To: CRA Board and Planning Board
Subject: Center Plaza Design Update
Date: August 5th, 2025

Plaza CRA/CDD Design Review Committee

CENTER PLAZA DESIGN UPDATE

Design Review Committee Discussion
August 19, 2025

The Beehive

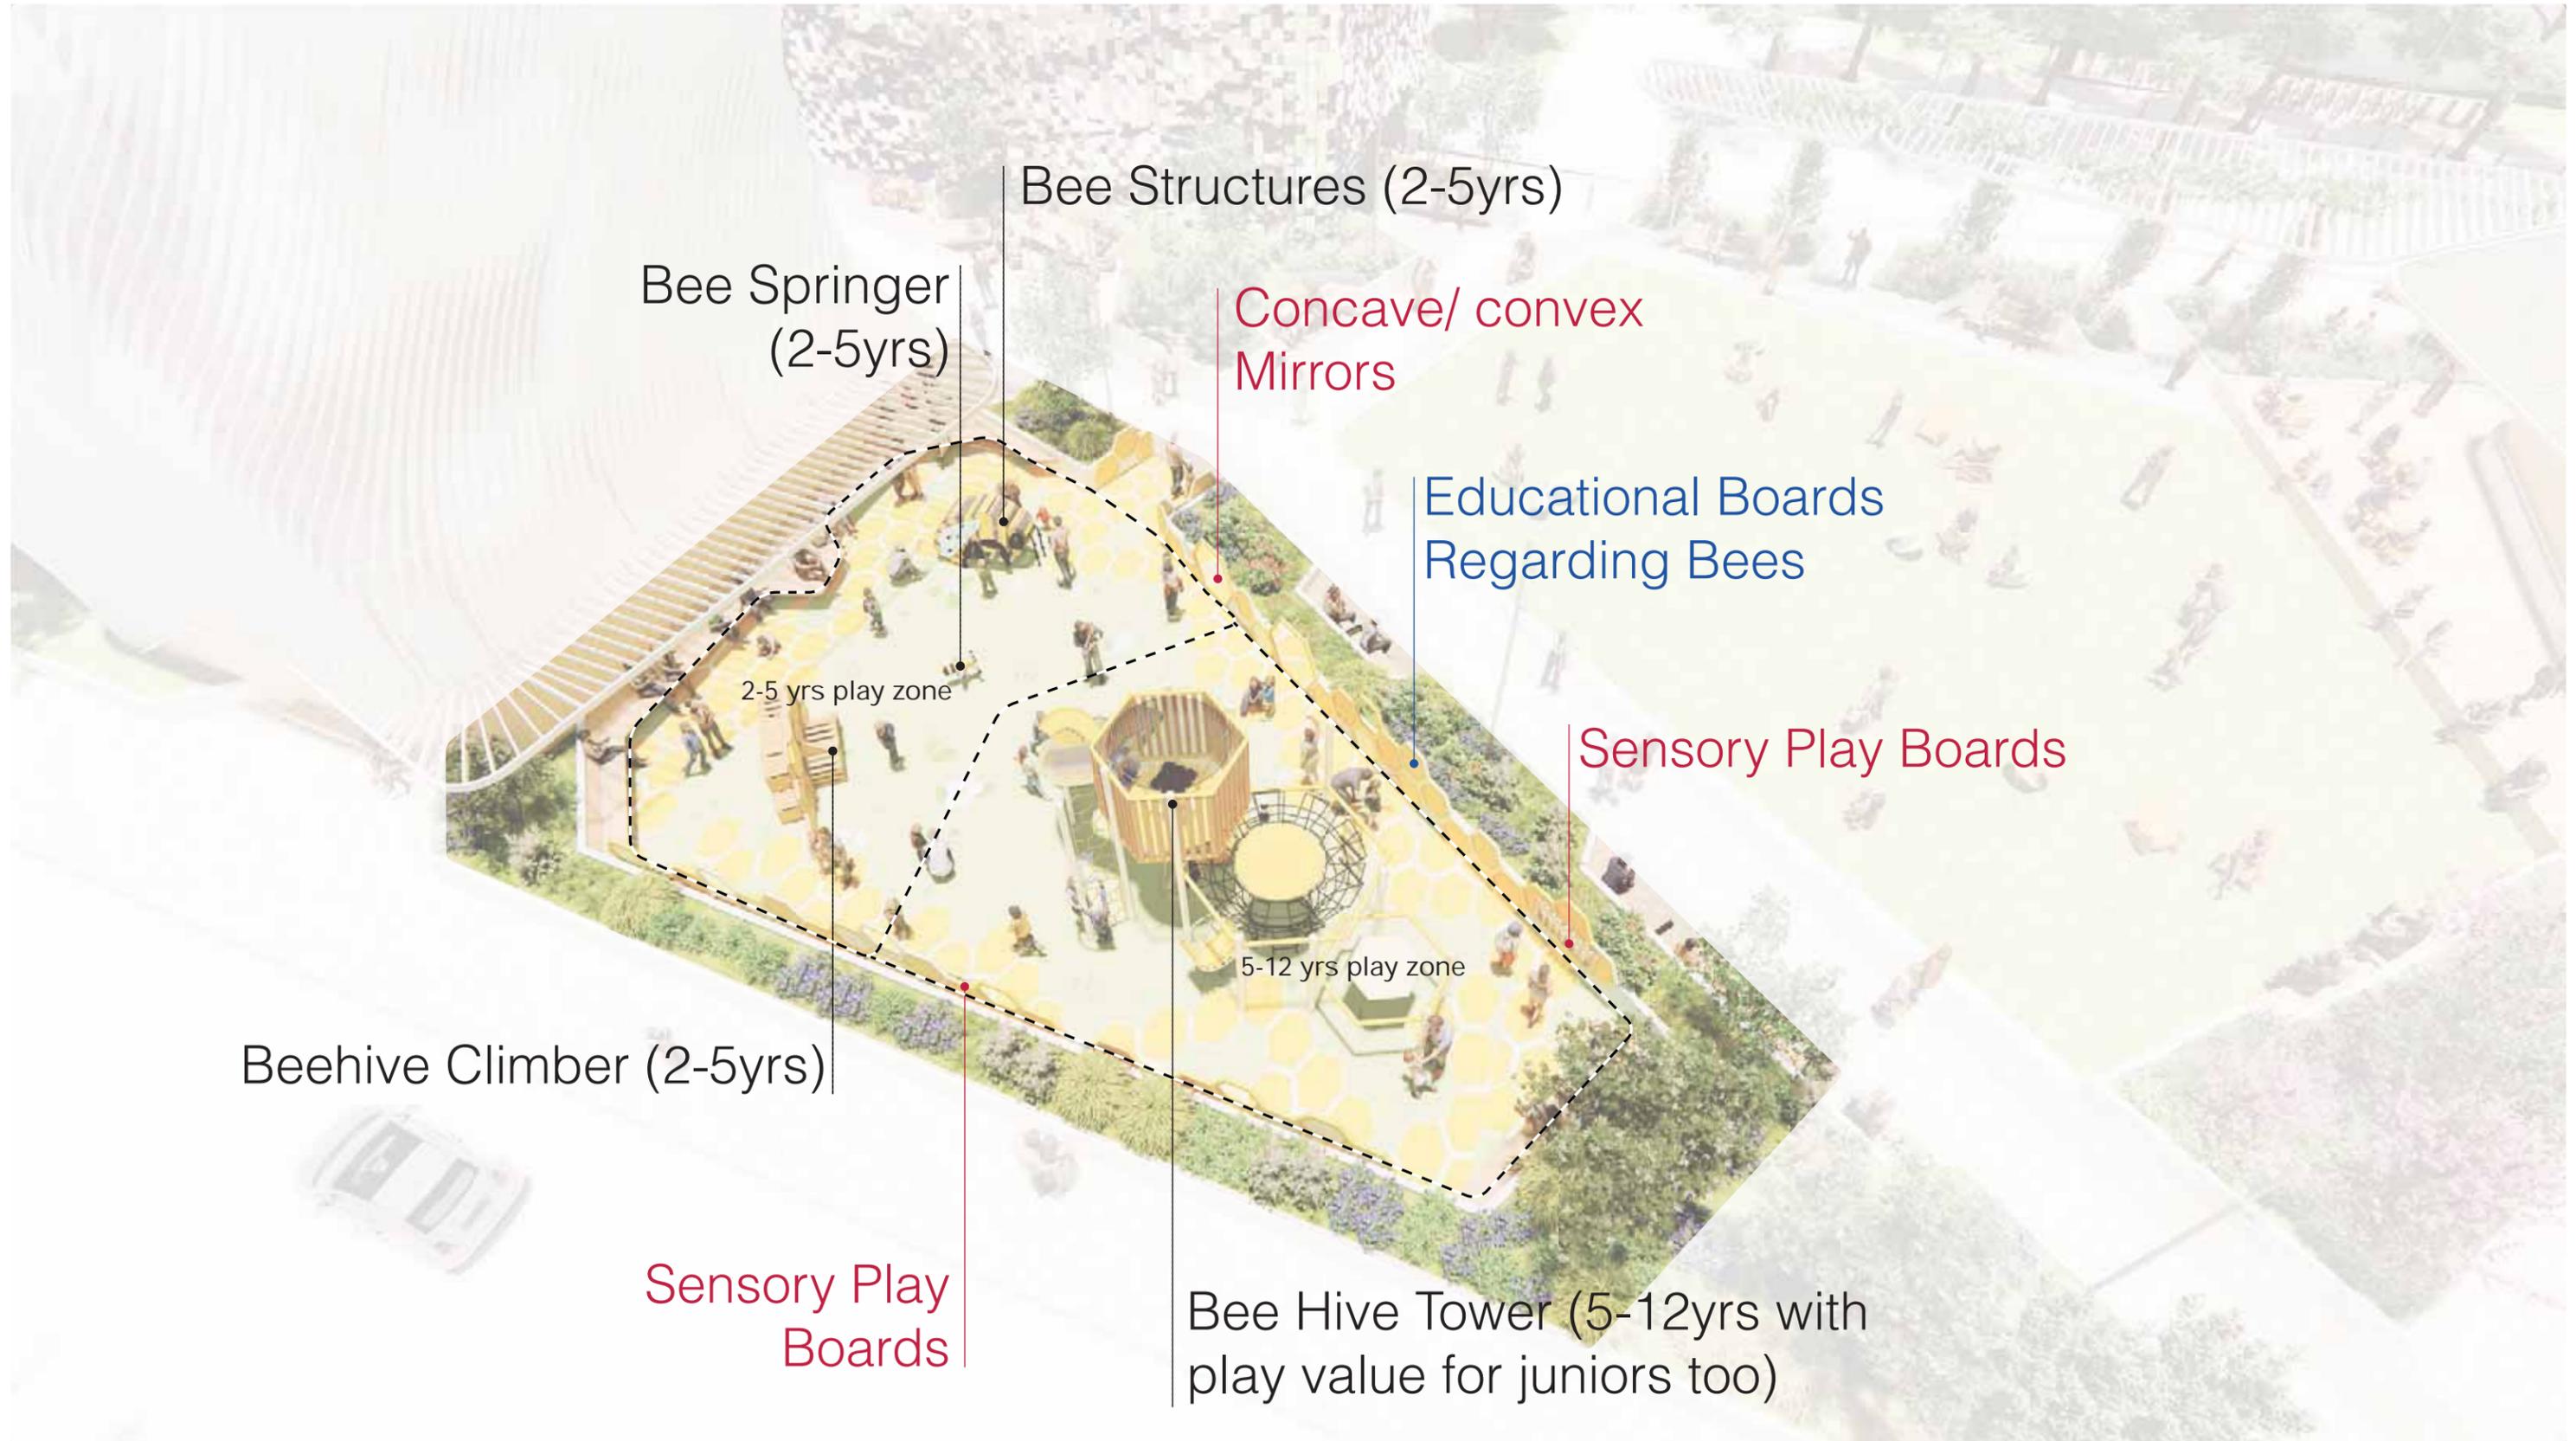
- Refine play structure material; mixed preference between wood and colorful structures, with a general preference to avoid rustic aesthetic.
- Enhance planting along play area edges.
- Increase variety and engagement, create a more immersive experience.
- Ensure adequate lighting and long-term durability.

Option 1 - The Bird's Nest

Option 2 - The Beehive

1. Add taller shrubs at east edge of plaza

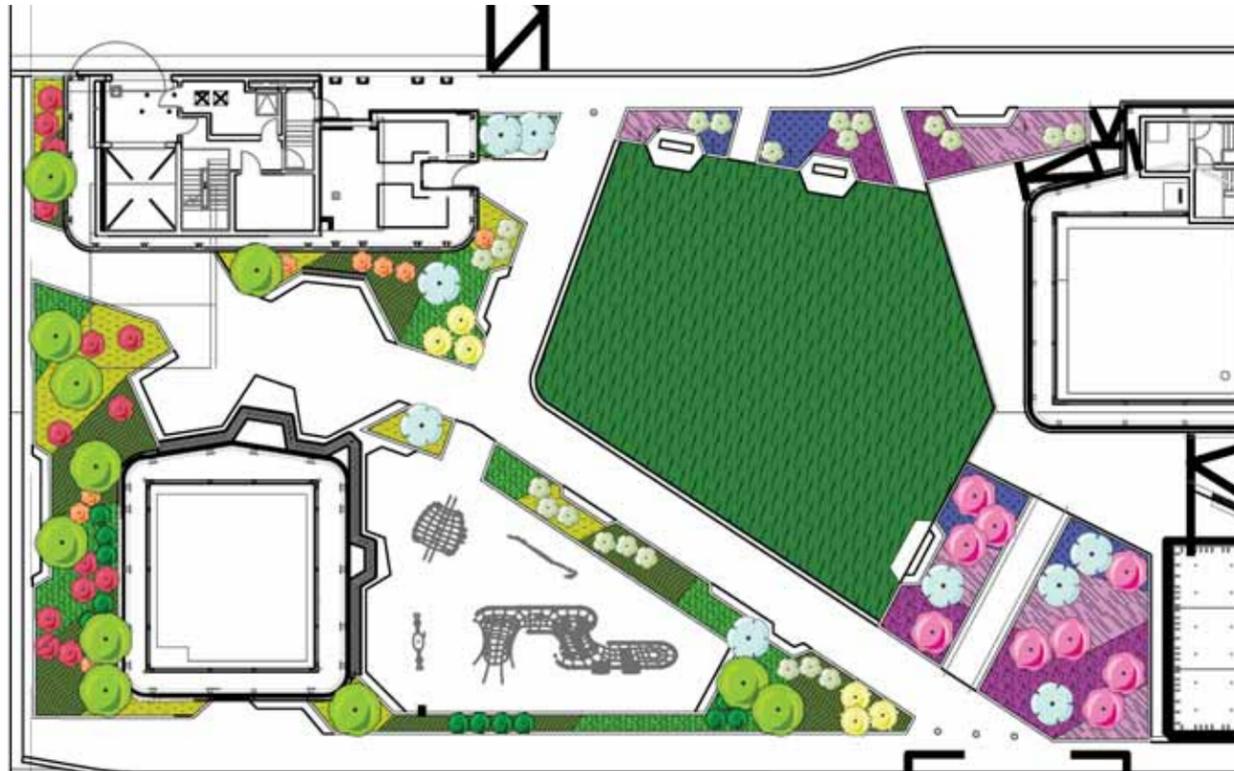
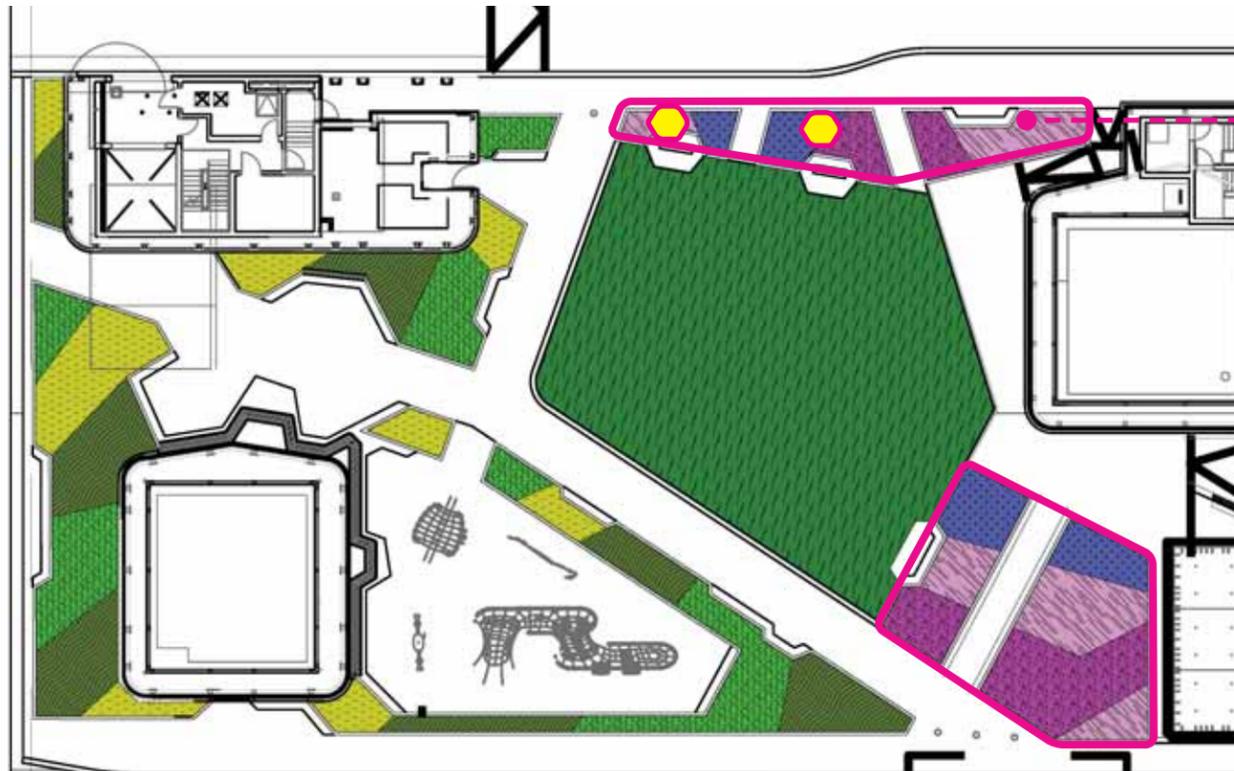
1. Add taller shrubs at east edge of plaza like vines on trellis at west side.
2. Provide more developed planting palette considering shade, wind, and rodent browsing. Will vines on trellis survive?
3. Consider lawn options (natural vs. synthetic)

Tall, multistem shrubs provide verticality, seasonal interest, and some shade, while allowing users to see underneath between park areas.

GLARE MAPPING FOR THE MOST EXTREME DAY OF THE YEAR

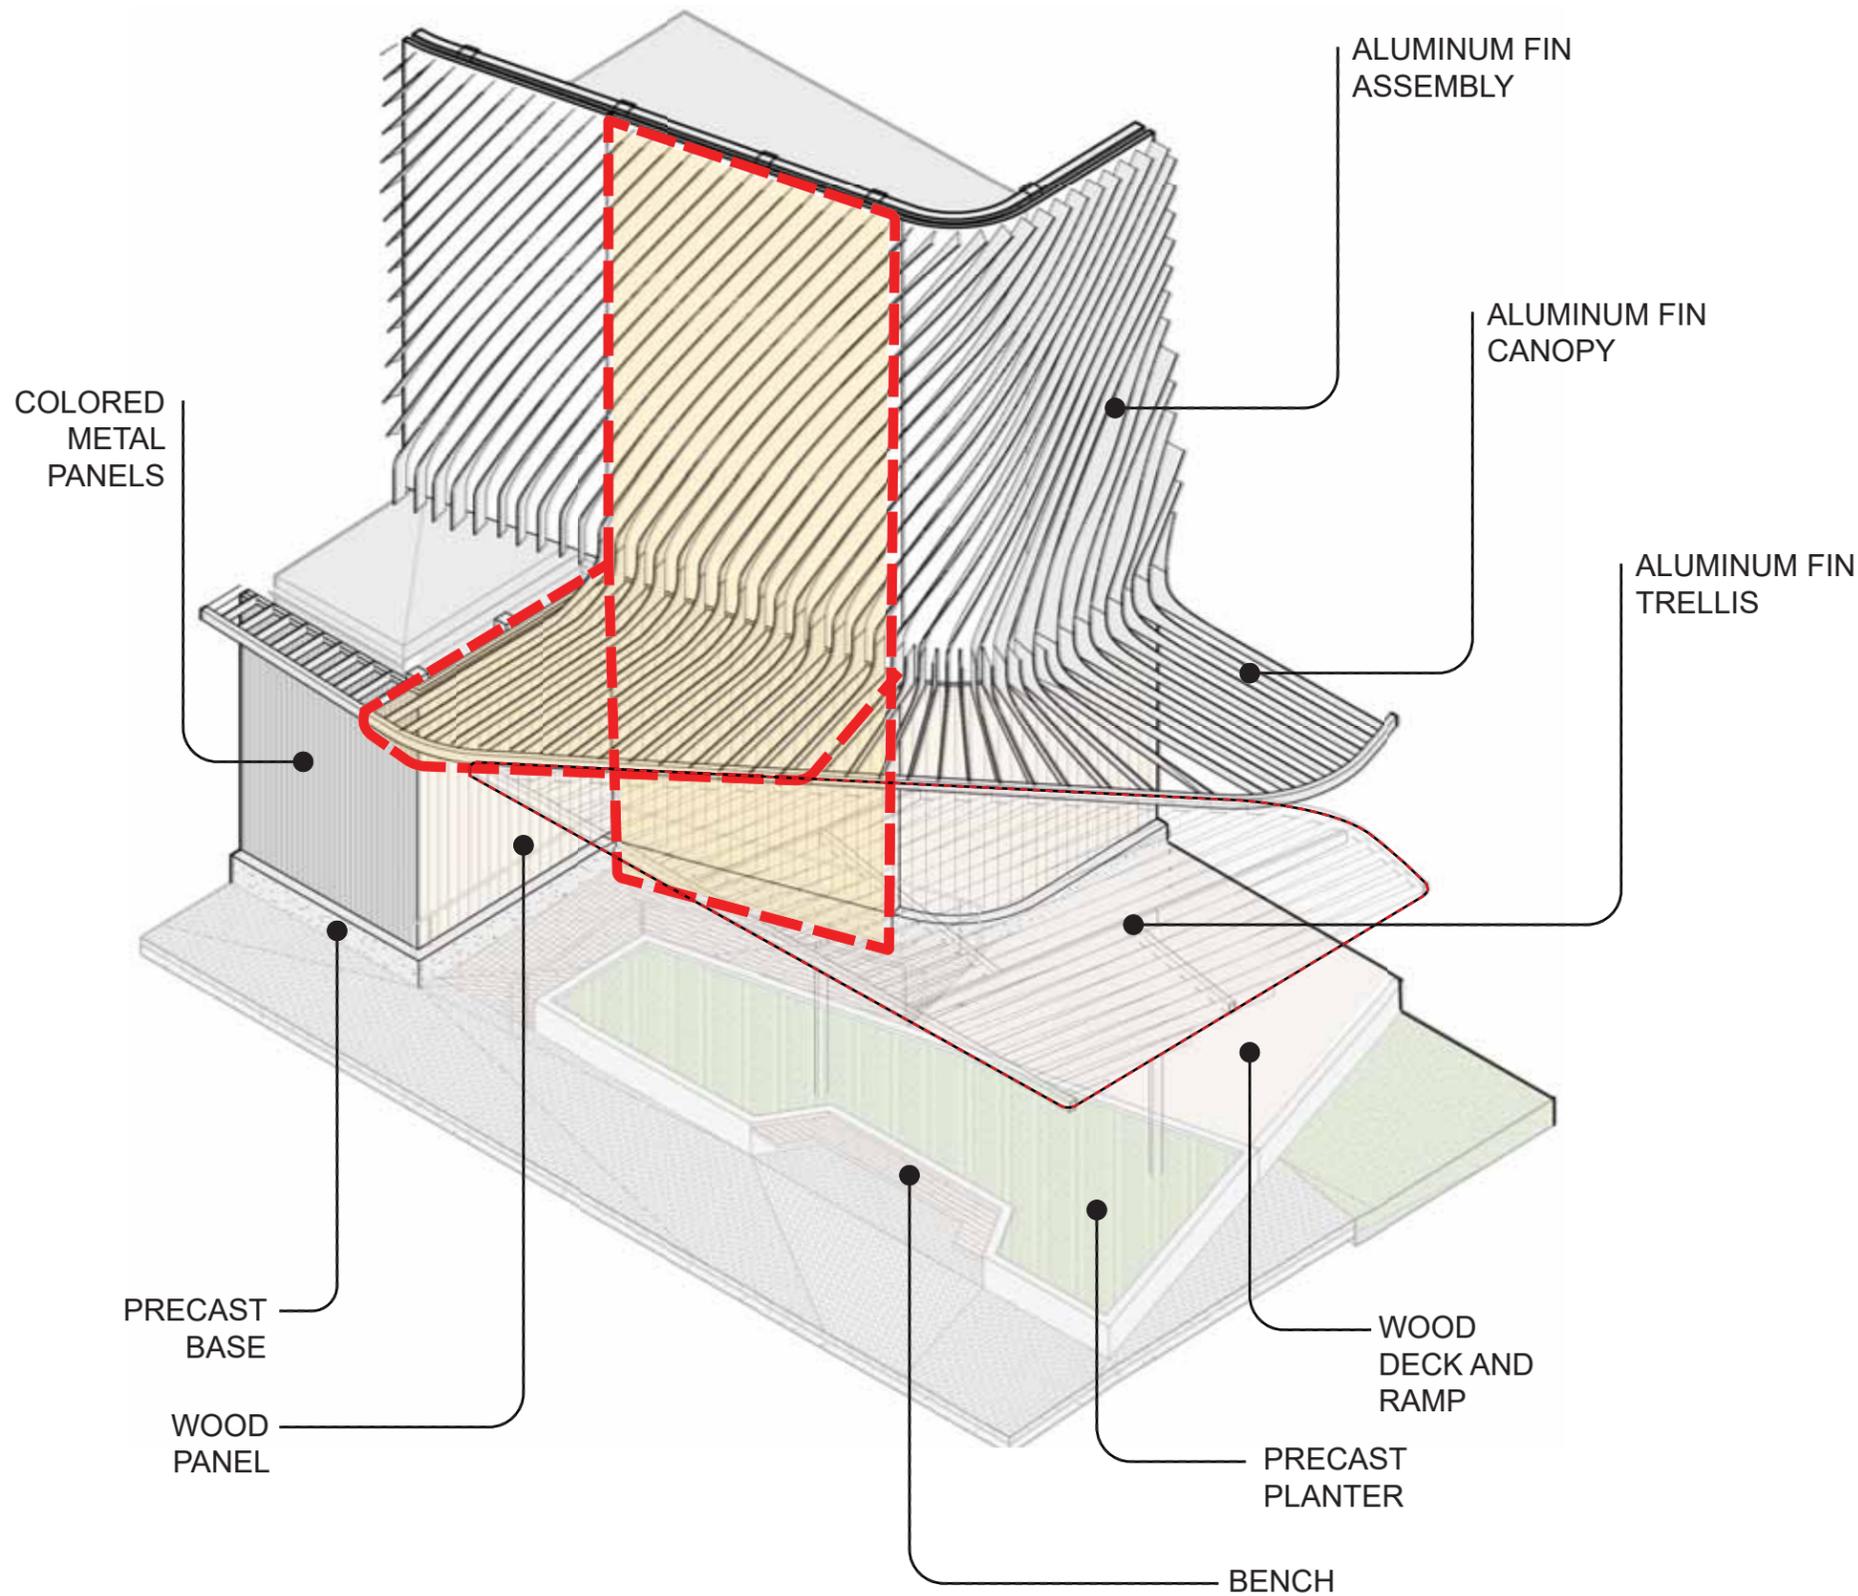
3. Consider safety of snow and ice buildup and UV radiation and glare from reflective surfaces

STRATEGY:

- IDENTIFY THE “HOT-SPOTS”.
- ADJUST SPECIFIC TILE ORIENTATIONS TO MITIGATE ANY ISSUES
